## **APPENDIX B. SWRCB DETERMINATION AND FEEDBACK**

## **Appendix B-1: State Water Resources Control Board Final Staff Report**

**State of California**  
**Department of Water Resources**  
**Sustainable Groundwater Management Office**  
**Groundwater Sustainability Plan Assessment Staff Report**

Groundwater Basin Name: San Joaquin Valley Basin – Kern County Subbasin (No. 5-022.14)  
Number of GSPs: 5 (see list below)  
Number of GSAs: 11 (see list below)  
Point of Contact: Patricia Poire, Kern Groundwater Authority  
Recommendation: Incomplete  
Date: January 28, 2022

Figure 1. Water level transect along cross section E-E' comparing Fall 2015, MO, and MT groundwater elevations.

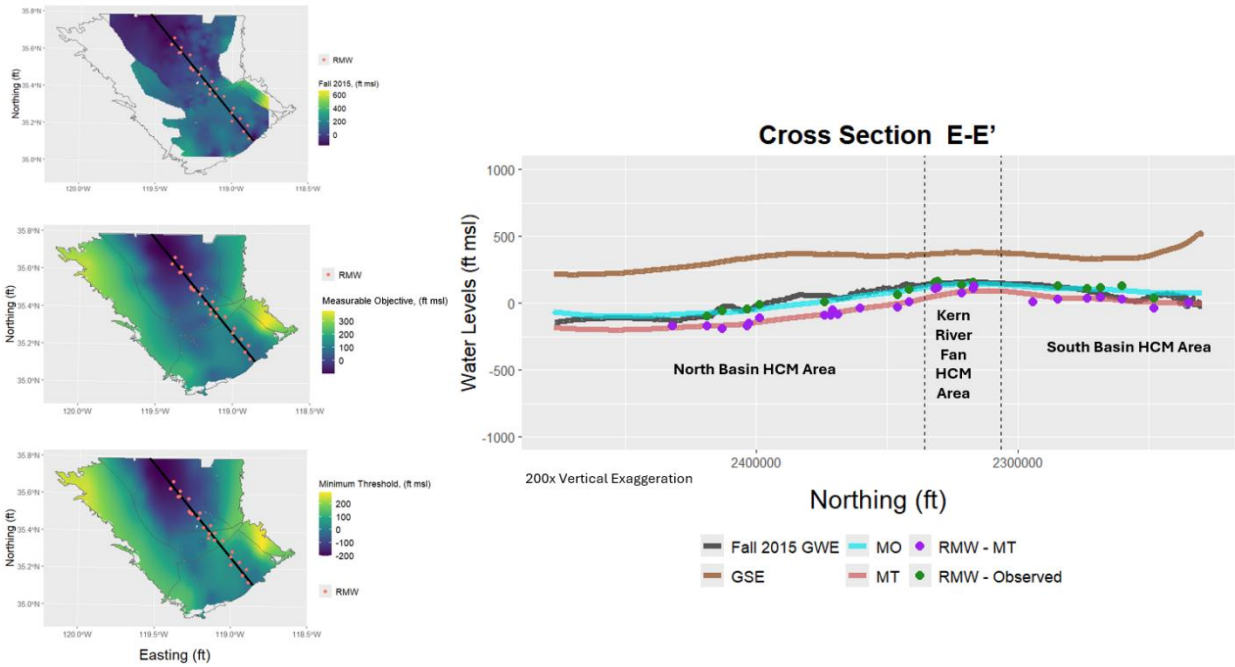
The SWRCB Draft Staff Report states that the “groundwater level MTs ... vary dramatically across ‘hydrological areas’ of the subbasin”. As shown in the contour maps and the three transects Figure 1, Figure 2, and Figure 3 below, the MT (and MO) values in fact do not “vary dramatically” between HCM Areas. They instead appropriately reflect the localized water level conditions across the Subbasin similar to those observed in Fall 2015. Similarly, spatial interpolations of the MTs and MOs at RMWs are similar to the Fall 2015 water level spatial interpolation. It should be noted

that the transects show smooth MT and MO interpolated values, and some of the apparent discrepancy at the RMW points is related to the translation across up to a two-mile distance to the transect lines.

Figure 5. Long-term Groundwater Levels and Land Subsidence (Sites A through D)

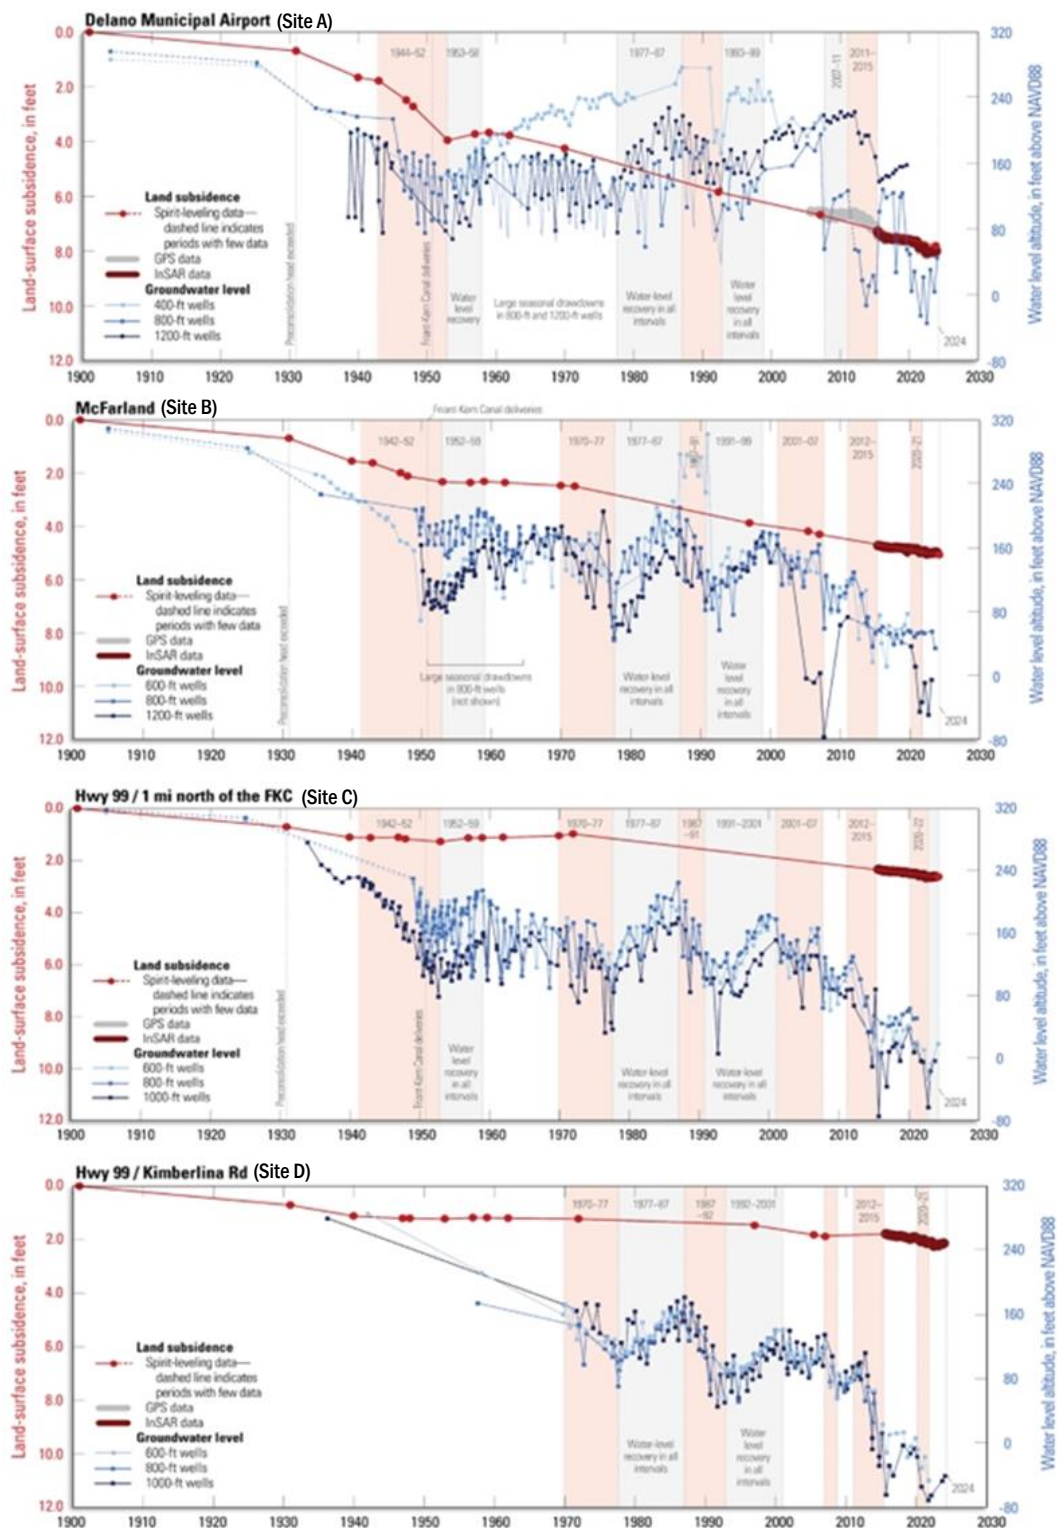
- *The GSAs do not demonstrate a fundamental understanding of the Subbasin’s settings. For example, monitoring well networks for groundwater levels and groundwater quality do not differentiate between confined and unconfined aquifers separated by the E-clay (a confining layer), or other clay layers. Most monitoring wells appear to be screened in the confined aquifer, and therefore may not be protective of all beneficial users when water levels in the unconfined aquifer are lower than that in the confined aquifer. An understanding of groundwater levels and groundwater quality in the unconfined and confined aquifers, as well as subsidence and groundwater quality, is essential for characterizing hydrogeologic conditions throughout the subbasin. Well impact analyses, monitoring plans, or mitigation strategies developed without this knowledge are insufficient and may not be protective of beneficial*

The variability of the E-Clay justifies establishing a single principal aquifer for the alluvial sediments. This is based on a fundamentally sound understanding of the Subbasin-wide hydrogeology. As an example of the hydraulic relationship along the northern fringe of the Subbasin, Figure 5 on the following page shows a series of hydrographs and land subsidence of nearby wells for four areas along Highway 99. The Delano Municipal Airport (Site A) is the furthest northern site within 2 miles of the boundary with the Tule Subbasin and shows examples of zonation among three aquifer zones at variable depth by location. The Highway 99 at Kimberlina Road (Site D) is the farthest southern location and only about 13 miles south of the Delano Airport. At the Delano Municipal Airport site, the groundwater elevations in the shallowest screened zone are higher than the lower zone at times but are nearly the same at other times. This relationship indicates the effects of local zonation as evidenced by increased subsidence at Site A compared to the other three sites that have similar groundwater elevations over the period of record. At the three more southern locations, the difference between the shallower and deeper screened intervals is minimal indicating little to no local zonation in these areas. The smaller magnitude of subsidence observed at the three southern sites compared to Site A is because the E-Clay and lesser clay layers diminish to the south (Figure 4). These wells provide an example of the observed hydraulic response observed in the Subbasin near the Friant-Kern Canal. While localized vertical head differences are present in some areas of the Subbasin, the alluvial aquifer at the Subbasin-scale is

hydraulically connected and can be managed as a single aquifer system.
